SERVICE BULLETIN

SERVICE BULLETIN INDEX

FIGURE 1
COMPRESSOR OUTLET DUCT COUPLING INSTALLATION

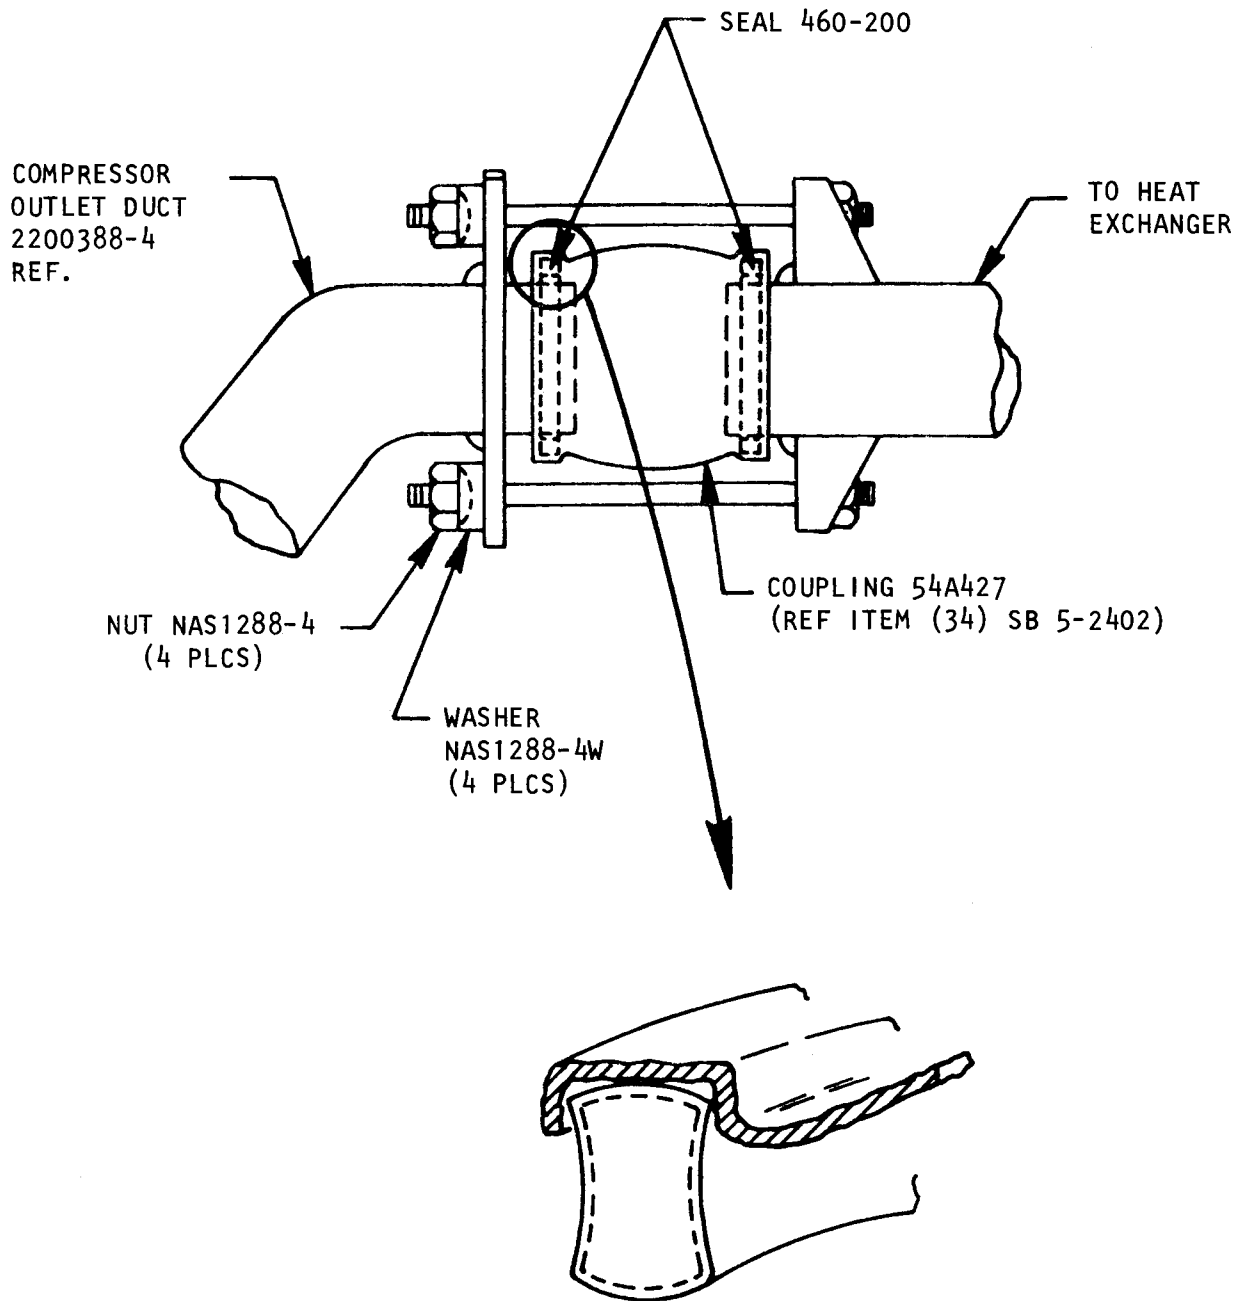
**See Figure 1 for seal installation.

Aircraft Refrigeration Unit
Part No. 2200165-2 and 2200165-3
Figure 1

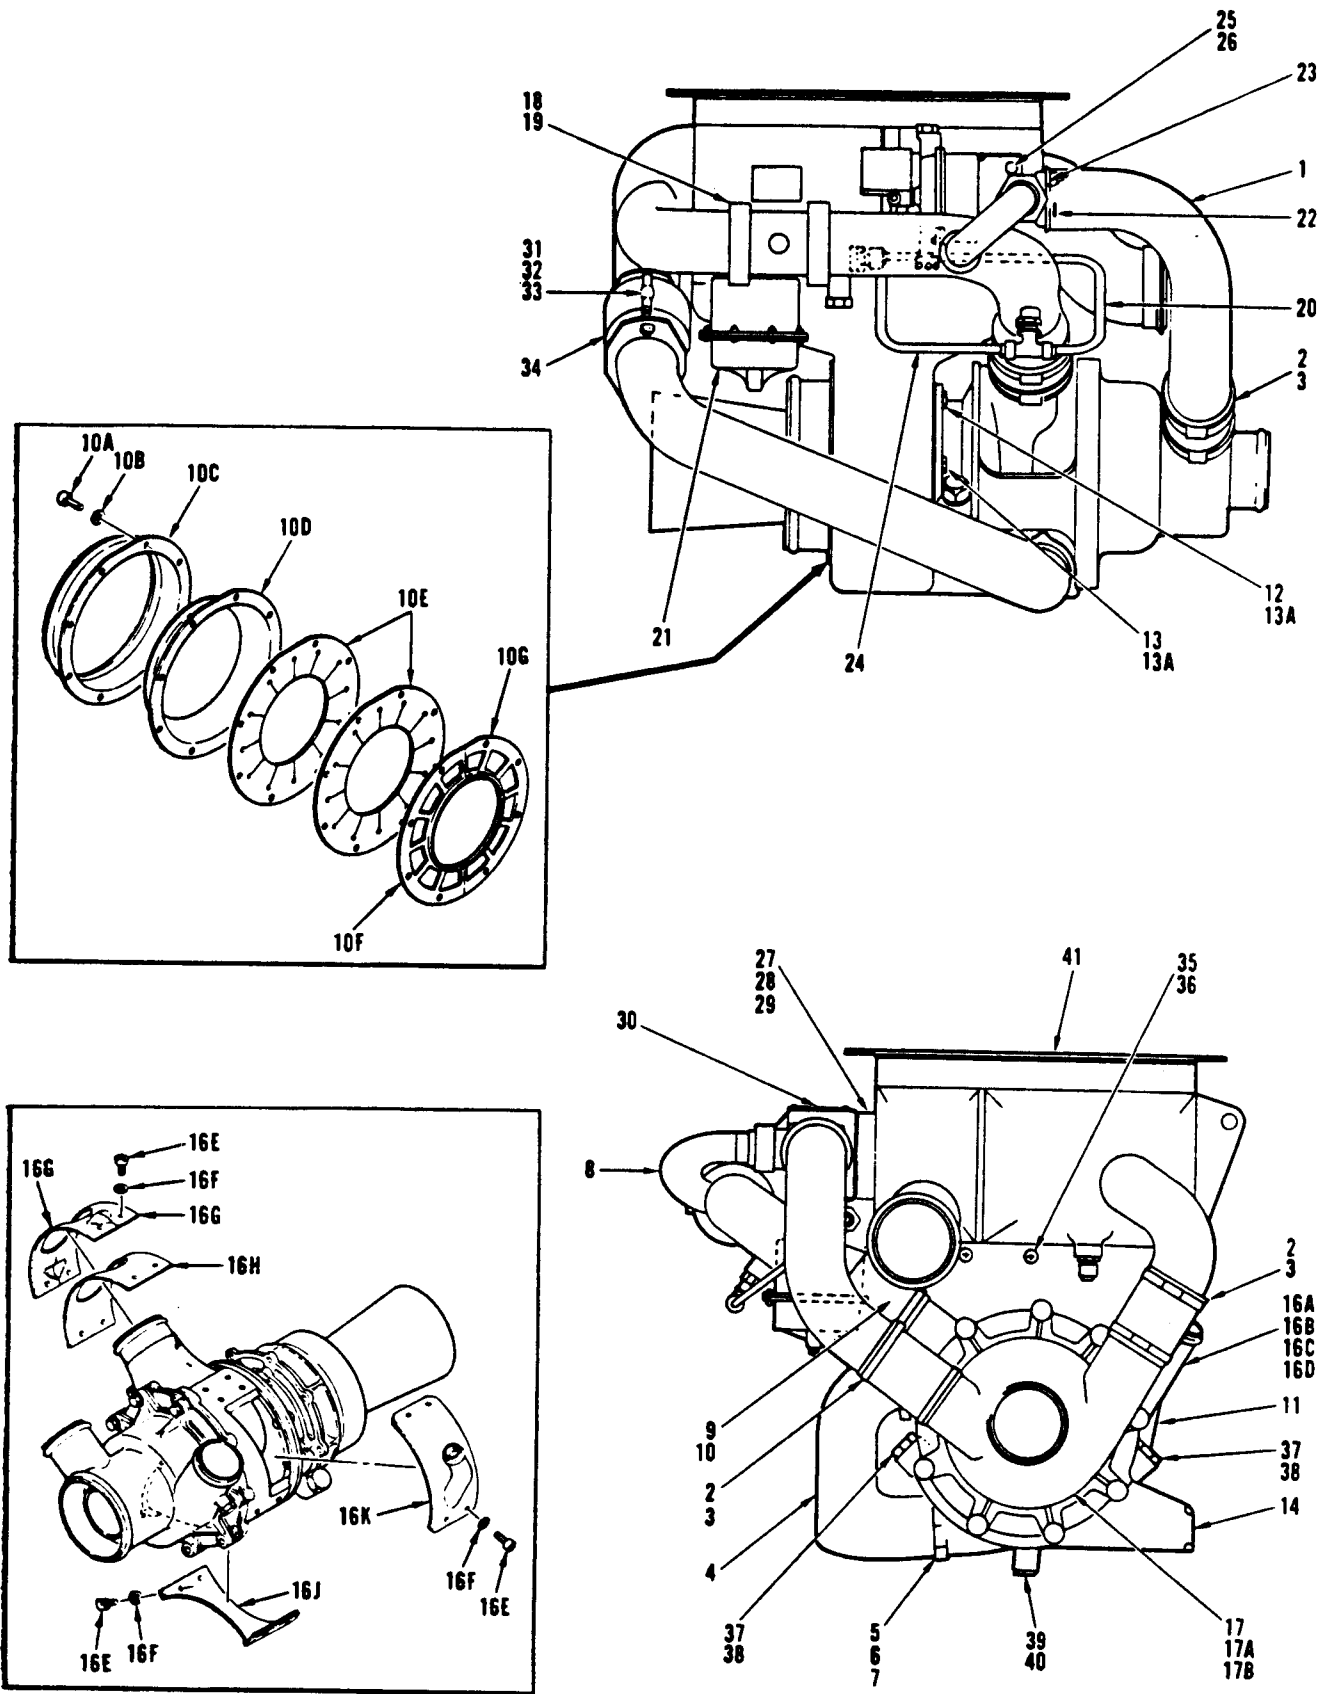
- (1) Remove 2200392-1 Regulating Valve Supply Pressure Tube Assembly (20, figure 1).
- (2) Remove 2200388-1 Compressor Outlet Duct Assembly (4) by removing three screws (5), nine washers (6), one packing (7), four nuts (31), four washers (32), two studs (33), and coupling (34) as shown in figure 1. Retain attaching hardware.

- (3) Install new 2200388-4 Compressor Outlet Duct Assembly (4A, figure 2) and secure with three screws (5), nine washers (6), one packing (7), four nuts (31), four washers (32), two studs (33), and coupling (34) as shown in figure 2.

- (4) Remove 898730-1 Fluid Pressure Regulating Valve (21, figure 1) by removing two clamps (18) and two packings (19) as shown in figure 1. Retain attaching hardware

- (5) Install new 898730-3 Fluid Pressure Regulating Valve as shown in (21A, figure 2) and secure with two packings (19) and two clamps (18) as shown in figure 2.

FIGURE 1

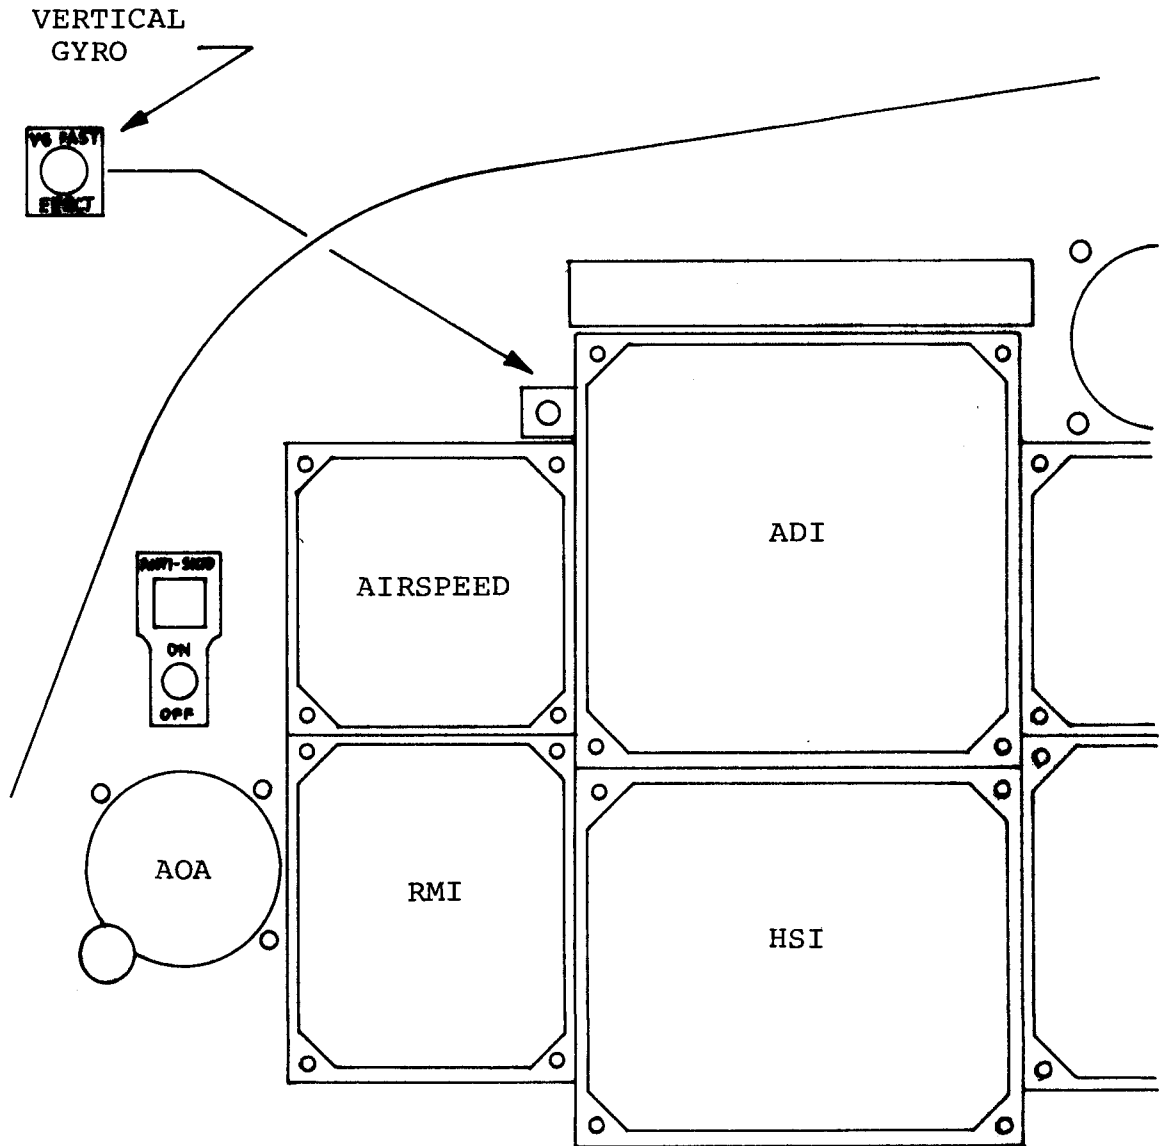
- (4) Locate vertical gyro fast erect switch on pilots instrument panel as shown in Figure 1, using standard shop practices. (Switch installation on copilot's panel is typical for aircraft with dual vertical gyro installations).

FIGURE 2

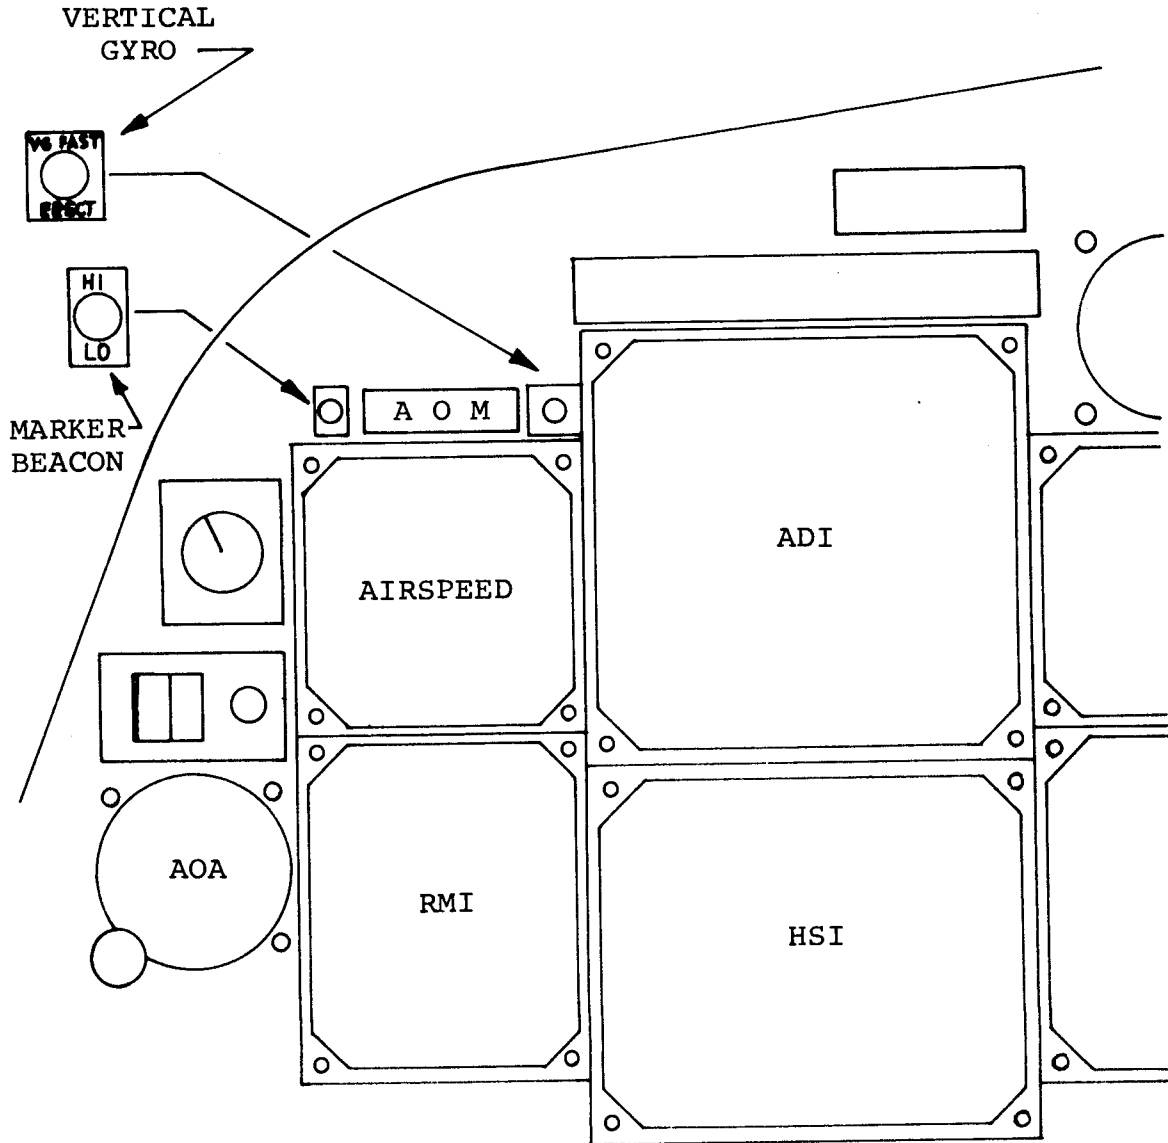
- (4) Locate vertical gyro fast erect switch on pilot's instrument panel as shown in Figure 1 or 2, using standard shop practices, (Switch installation on copilot's panel is typical for aircraft with dual vertical gyro installations).

FIGURE 1

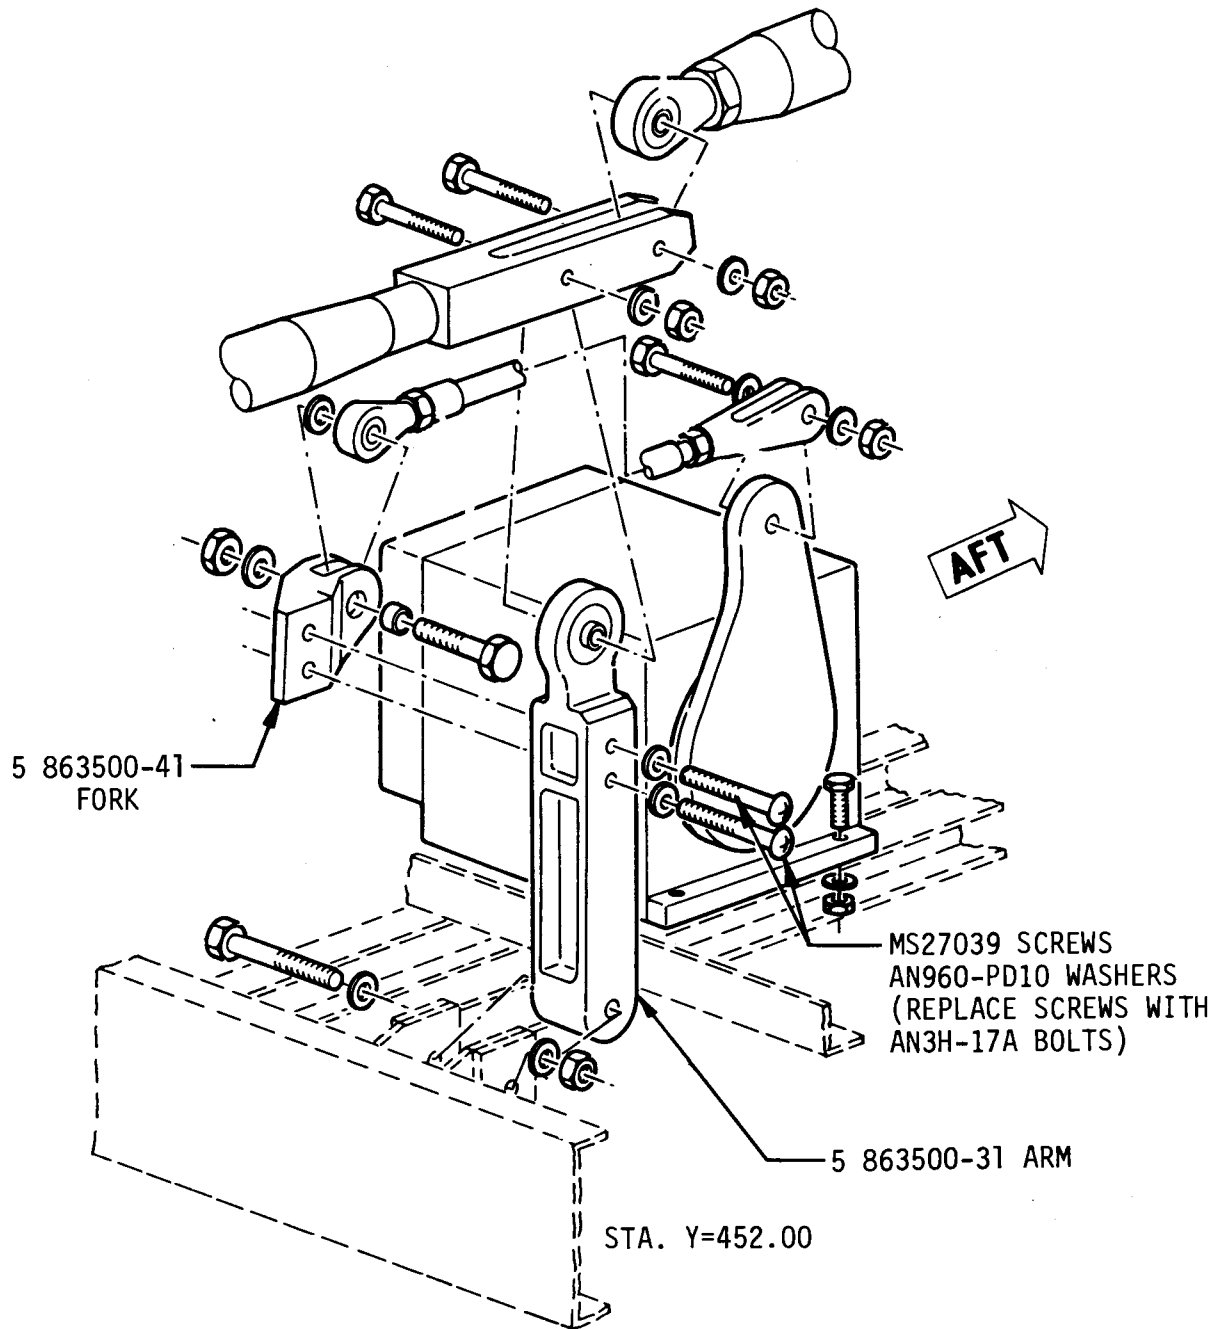
- A. Remove overhead access panels in aft baggage compartment as necessary to gain access to P/N 863500-31 arm and 863500-41 fork, ref. Fig. 1.
- B. Remove 2 each MS27039 screws and 2 each AN960-PD10 washers, discard screws and retain washers.
- C. Install 2 each AN3H-17A bolts with AN960-PD10 washers under heads. Torque to 20-25 inch-pounds and safety wire.

FIGURE 3
BLANKING CONNECTOR ASSEMBLY INSTALLATION

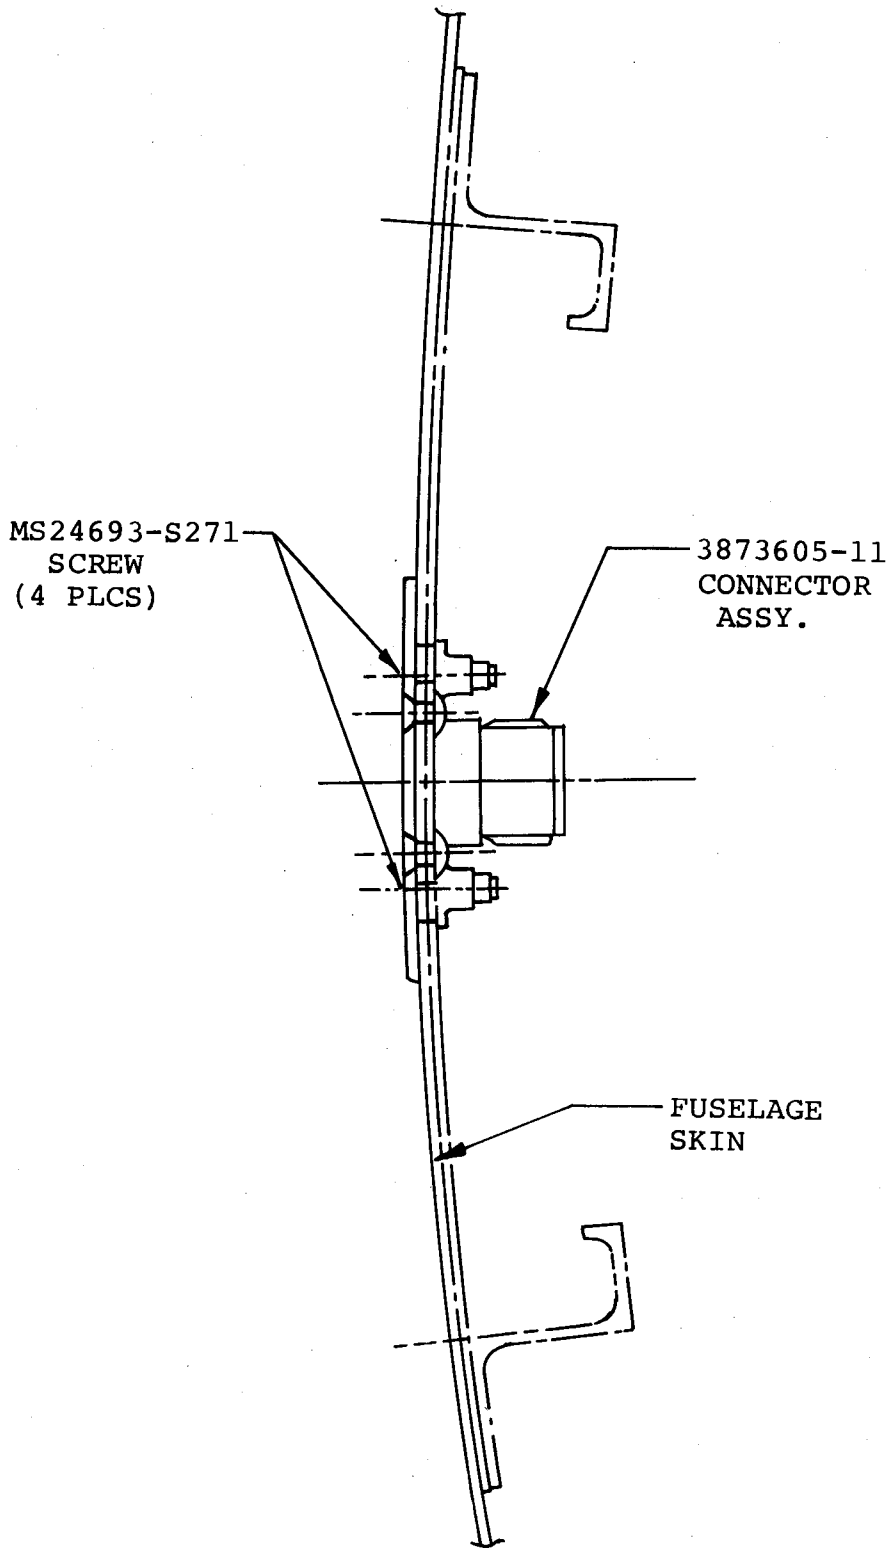
1. Disconnect coaxial antenna lead.
2. Remove existing flight telephone antenna.
3. Install blanking plate connector assembly P/N 3873605-11 using 4 ea. screws MS24693-S271. Apply PR1422B as required. Ref. Figure 3.
4. Connect the existing coaxial antenna lead to the blanking plate dummy connector and secure lead as required.
